**COLORADO**  
**Department of Transportation**

June 4, 2020

SH21A  
El Paso County

RE: Trails at Aspen Ridge Filing #2 (Springs East at Waterview) - EA-SF1927

## Powers Boulevard - 60-Inch Culvert

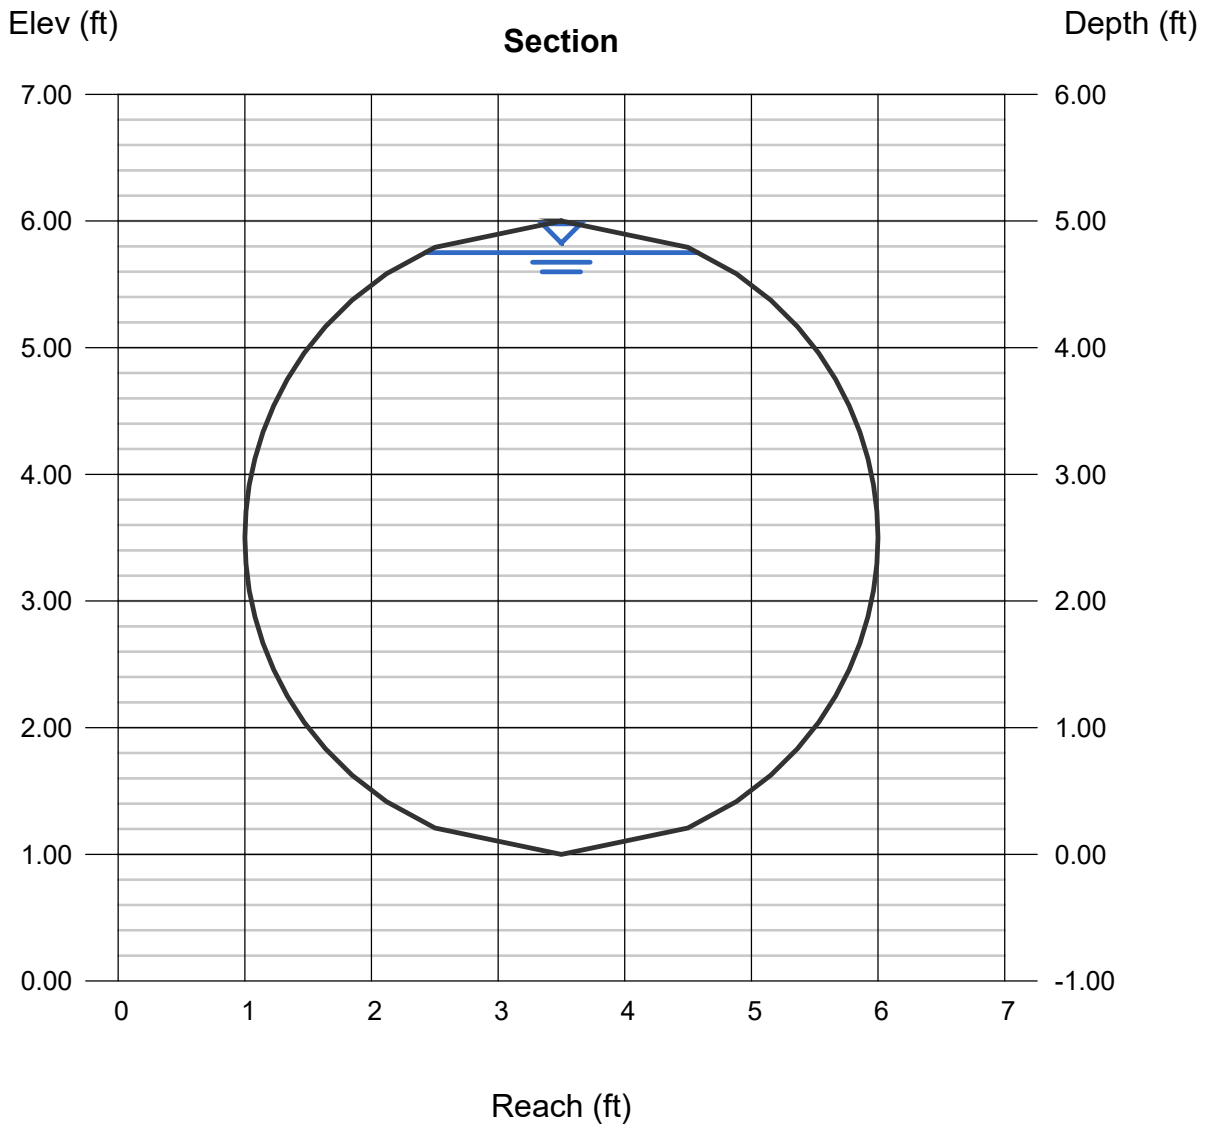
- a. Review of the Master Drainage Study dated June 2019.
- b. Please provide calculations that show the capacity of the culvert crossing Powers, and how the Pond outfall and basin that don't drain to the pond affect the capacity of this culvert.  
Capacity of 60" culvert calculated to be 291 cfs. Anticipated Q100 (Equal to or less than pre development value) is 54.26 cfs.

Q (cfs) = 291.02

## Powers Ditch: Total flows including Ultimate West Pond Discharge

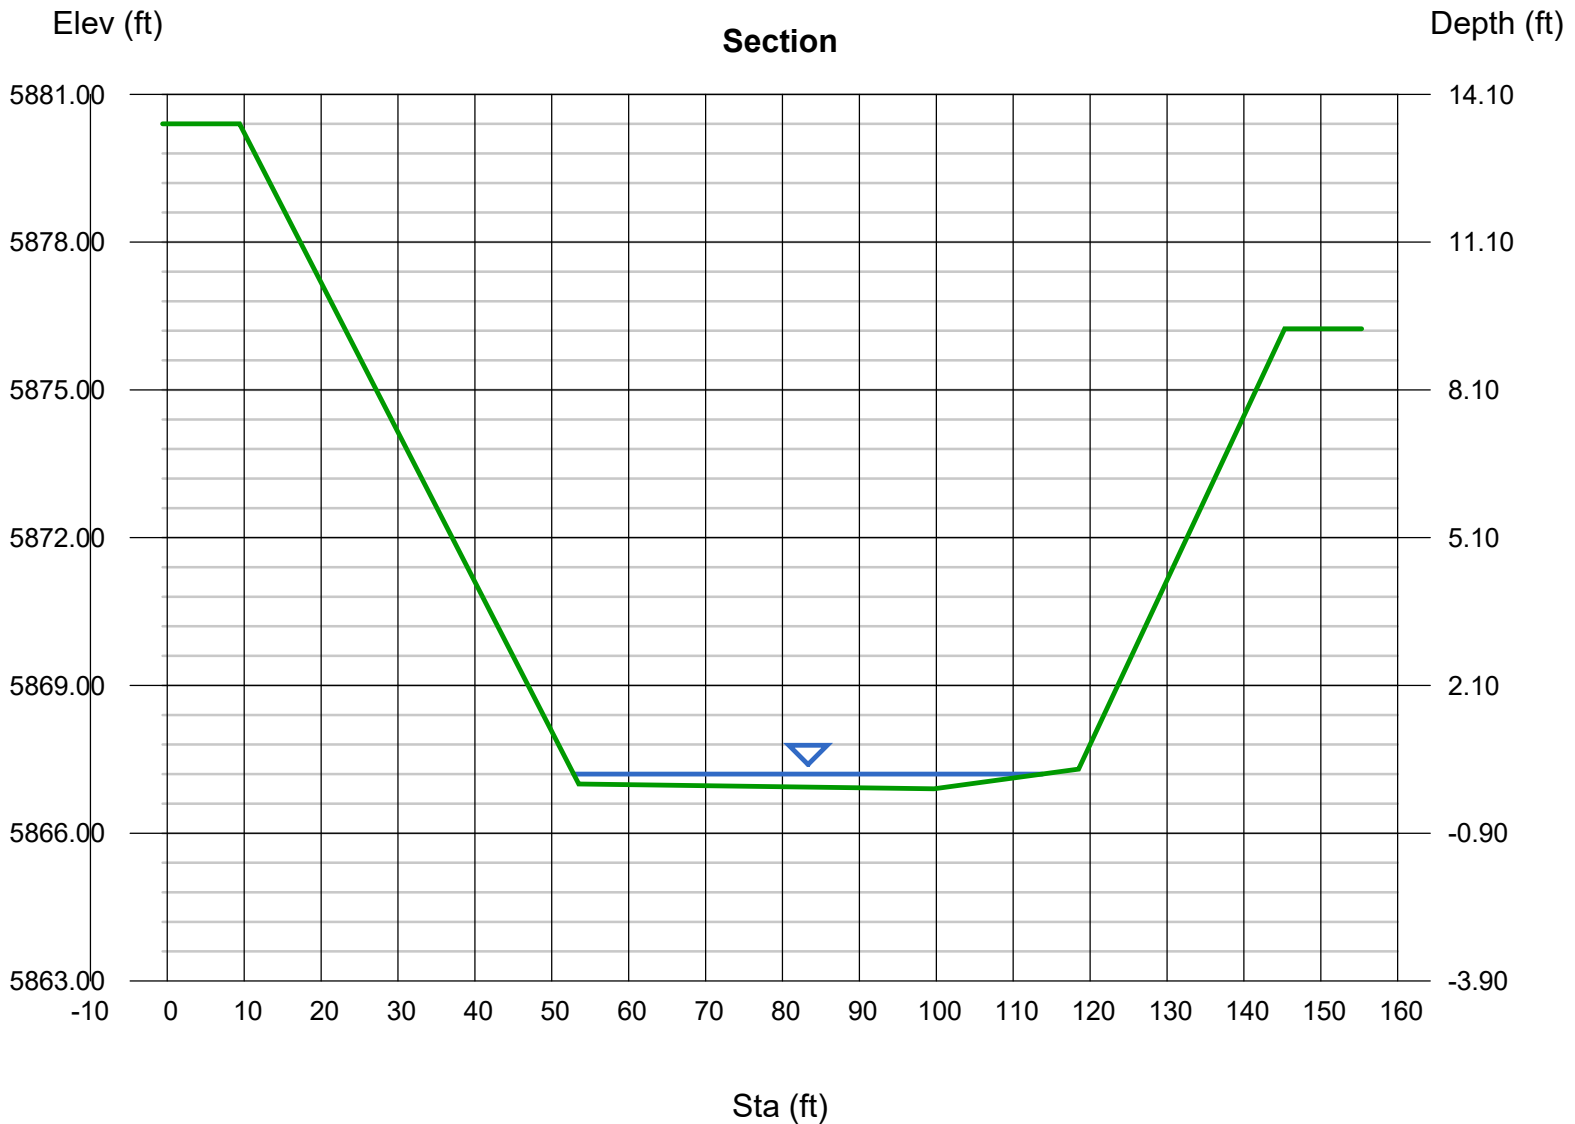
- f. Previous comments on the Powers culvert capacities and minor flow cleansing velocity have not been addressed underlined above. Please provide calculations showing that the CDOT drainage infrastructure is not affected by this development. Include hydrology showing existing vs. proposed overall basin area tributary to culverts crossing under Powers as well as hydraulic analysis of each culvert.

The above items were addressed in the Trails at Aspen Ridge Filing No. 1 FDR. Please see excerpts from the report below:

## Powers 60-inch Culvert - Minor Storm Event

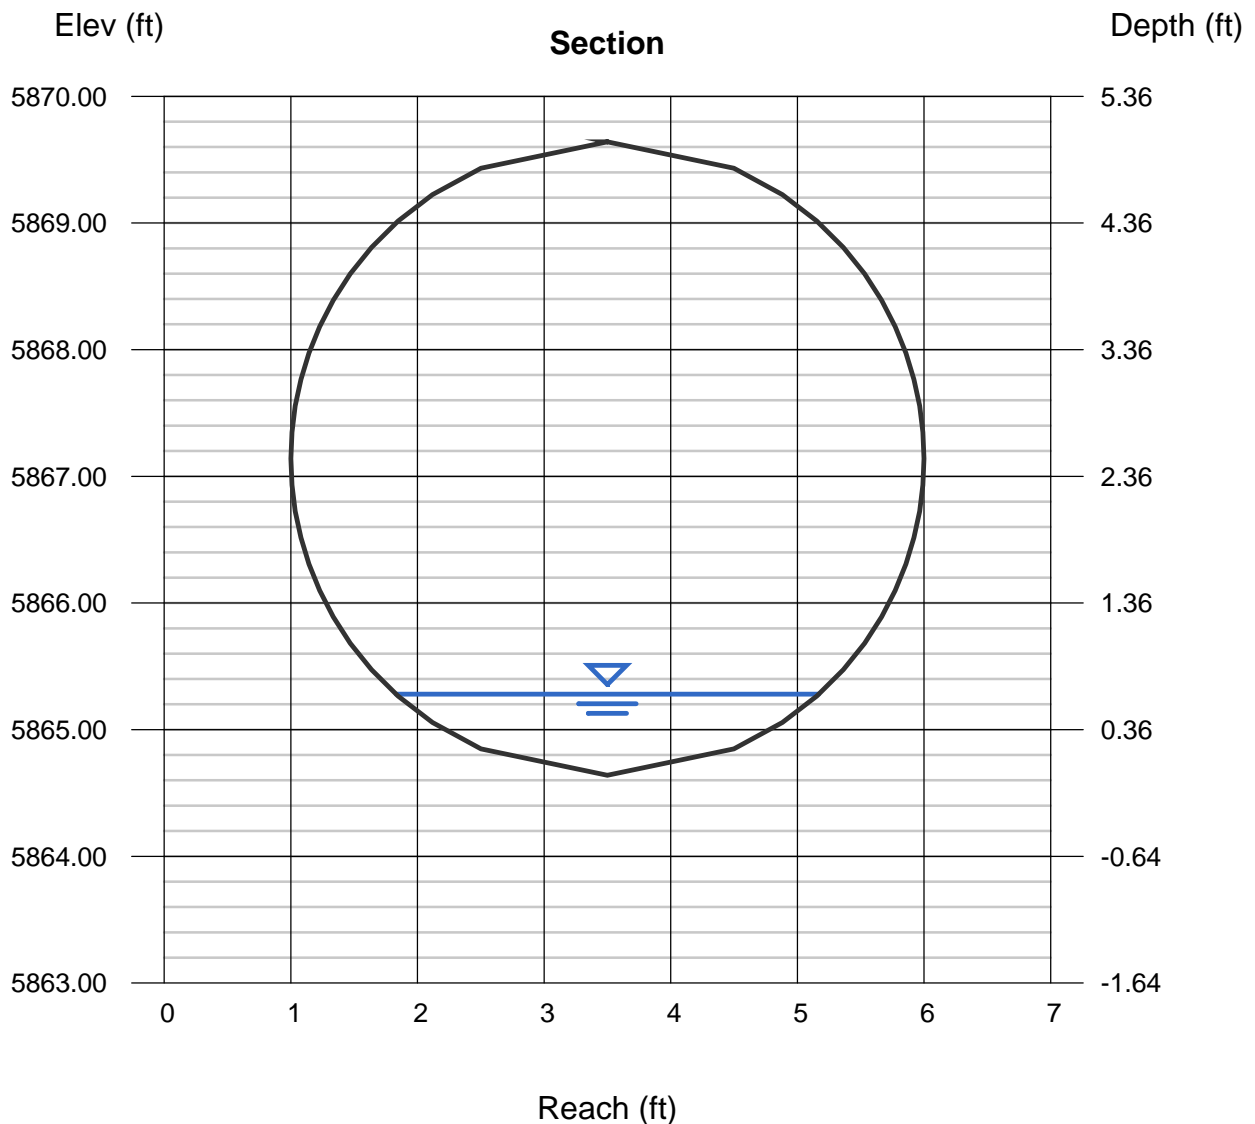
- d. Also, the 60" culvert needs to be checked that minor storm event flows will produce velocities high enough to provide self cleaning velocity, per CDOT requirements.  
Anticipated velocity of 6.4 ft/s for Minor Storm which complies with CDOT requirements.

CDOT Drainage Design  
Manual, Page 9-20:  
Minimum Velocity for  
Minor Event = 3 ft/s

## Powers 60-Inch Culvert - Major Storm Event

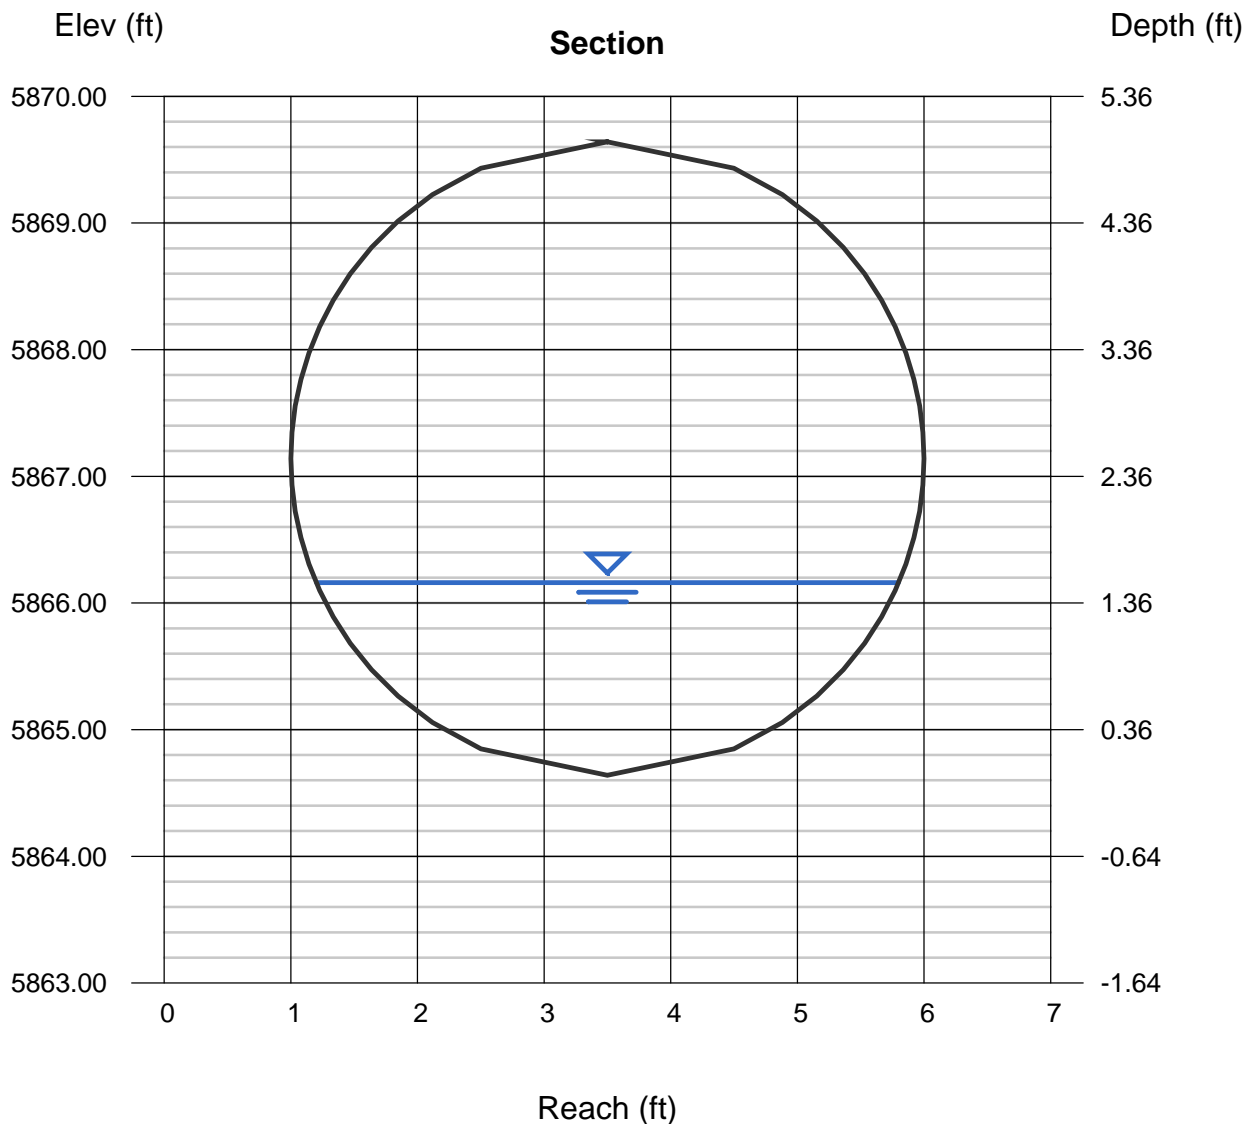
- c. It looks like the southern portion of the Big Johnson Basin is draining south to the existing 48" culvert in the existing condition. Please verify that changing the drainage patterns by capturing and conveying runoff from this area to the detention pond and then to the 60" culvert doesn't cause issues downstream.  
See below.

Note: Maximum Discharge (54.26 cfs) to the Powers Ditch will be slightly lower than the estimated pre-project value of 59.6 cfs (Based on a 44.9 Acre Tributary Area). No downstream issues are anticipated.
